PURNELL SUBDIVISION

APPLICATION NUMBER 6 DATE November 16, 2006

REQUEST Subdivision

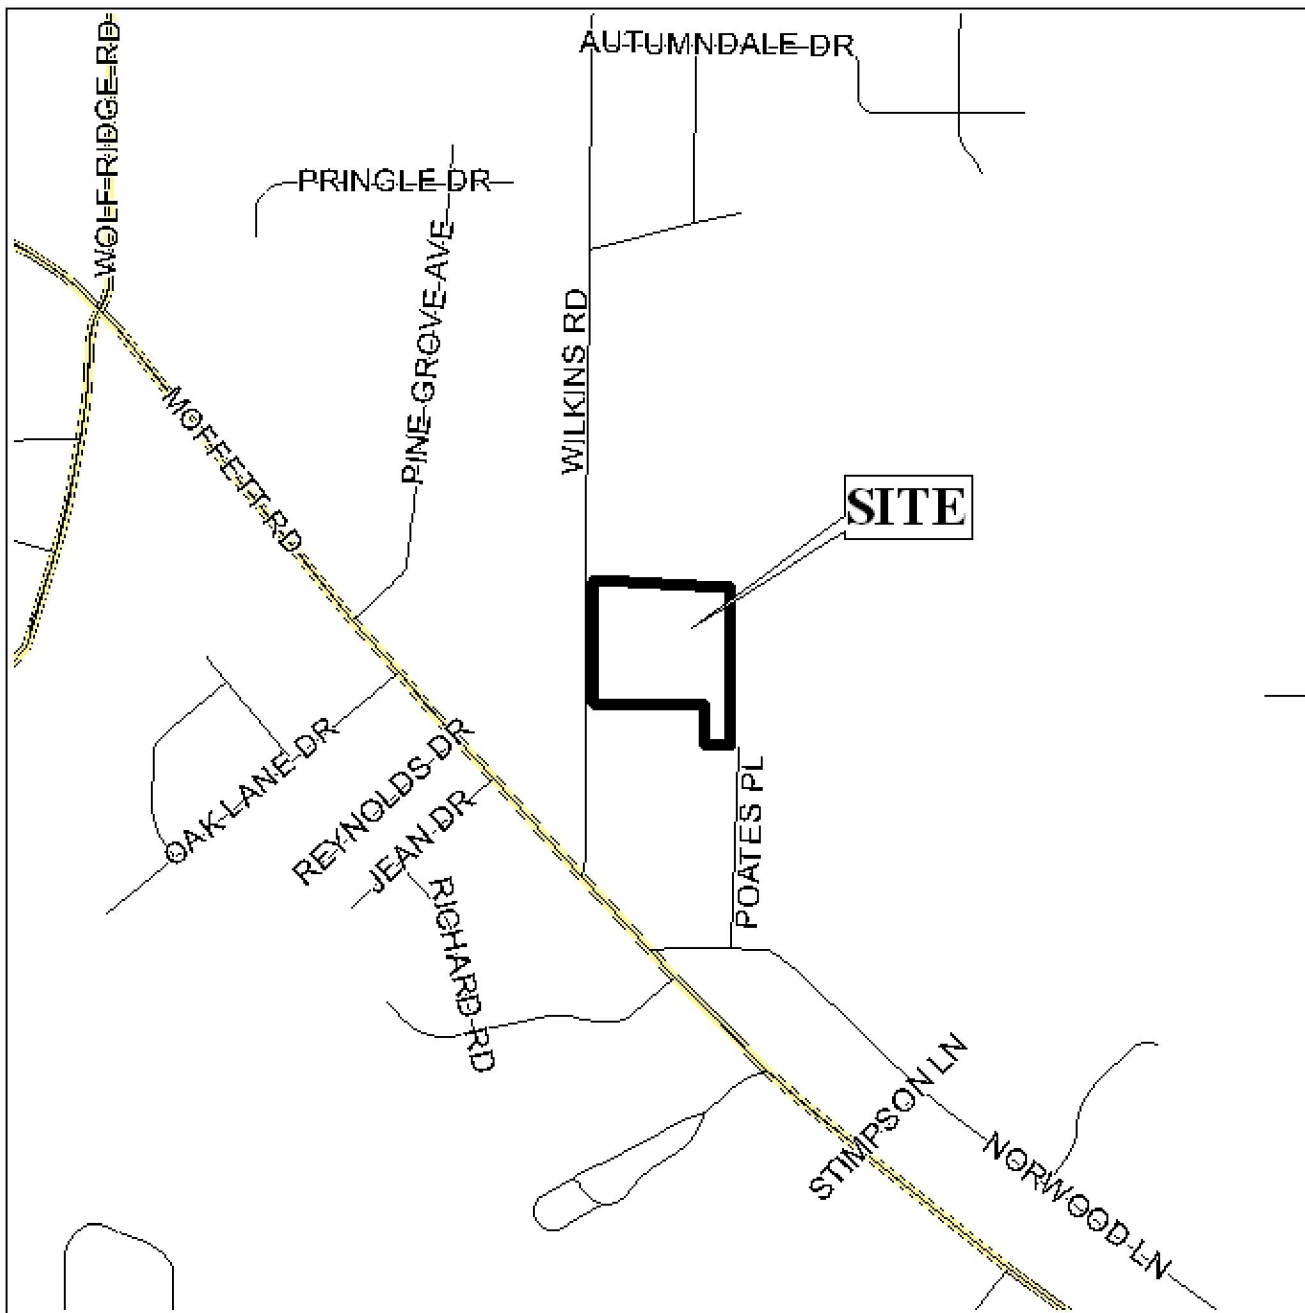
The site fronts onto Wilkins Road, a minor street lacking curb and gutter. The existing right-of-way for Wilkins Road is 50-feet, which is less than the 60-feet required for roads lacking curb and gutter. Therefore, the 25-foot minimum building setback line should be adjusted to reflect a right-of-way edge as measured 30 feet from the centerline of Wilkins Road.

While Wilkins Road is a minor street, access management is a concern. Proposed lot 1 should be limited to one curb-cut, and proposed lot 2 should be limited to two curb-cuts, with the size, design and location to be approved by Traffic Engineering and comply with AASHTO standards.

The proposed lot 1 will exceed the depth to width ratio recommended in Section V.D.3. of the Subdivision Regulations, however, a waiver may be appropriate due to the unusual shape of the parent parcel. Further subdivision of lot 1 should be denied until additional frontage on a public street is provided.

With a waiver of Section V.D.3., the plat is recommended for Tentative Approval, subject to the following conditions: 1) provision of additional setback sufficient to provide 30-feet, as measured from the centerline of Wilkins Road, and adjustment of the 25-foot minimum building setback line to account for the future right-of-way edge; 2) placement of a note on the plat stating that lot 1 is limited to one curb-cut, that lot 2 is limited to two curb-cuts, and that the size, design and location of all curb-cuts must be approved by Traffic Engineering and comply with AASHTO standards; 3) placement of a note on the plat stating that there shall be no future

subdivision of lot 1 until additional frontage on a public street is provided; 4) labeling of each lot with its size in square feet, or provision of a table on the plat with the same information; and 5) full compliance with all other municipal codes and ordinances.
